State P No. 003

REVISED WORK PLAN

NMOCD Case #: 1R-4466

NMOCD approves of the delineation and proposed remediation for 1RP-4466 with these conditions:

Proposed Work

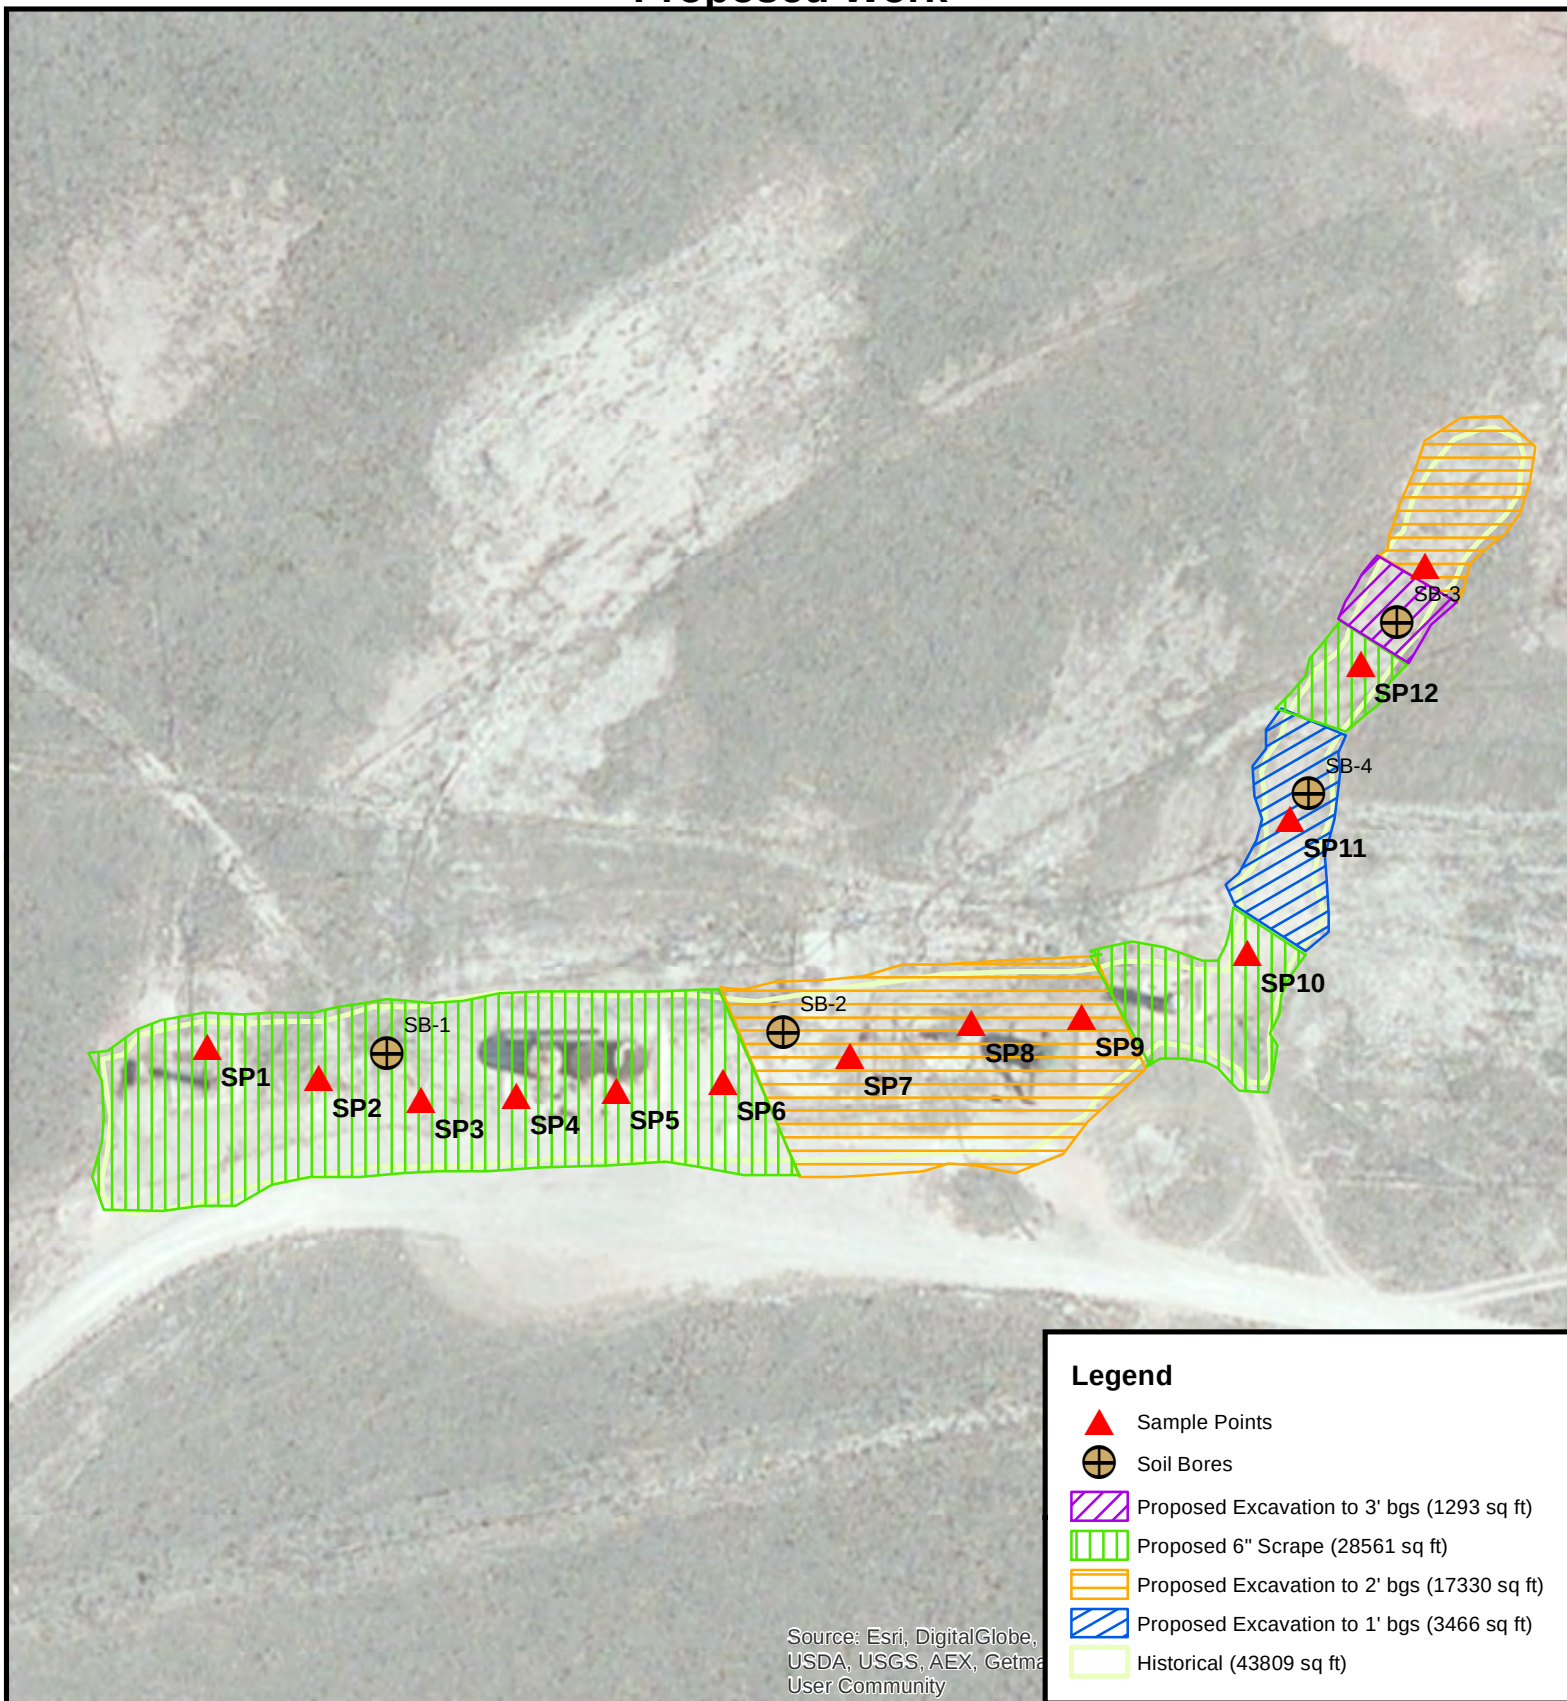
- 1) Laboratory analyses (BTEX, TPH extended, and chlorides) of bottom and sidewall samples taken for each for the excavated areas.
- 2) Delineation within the battery will be completed while on site for remediation.
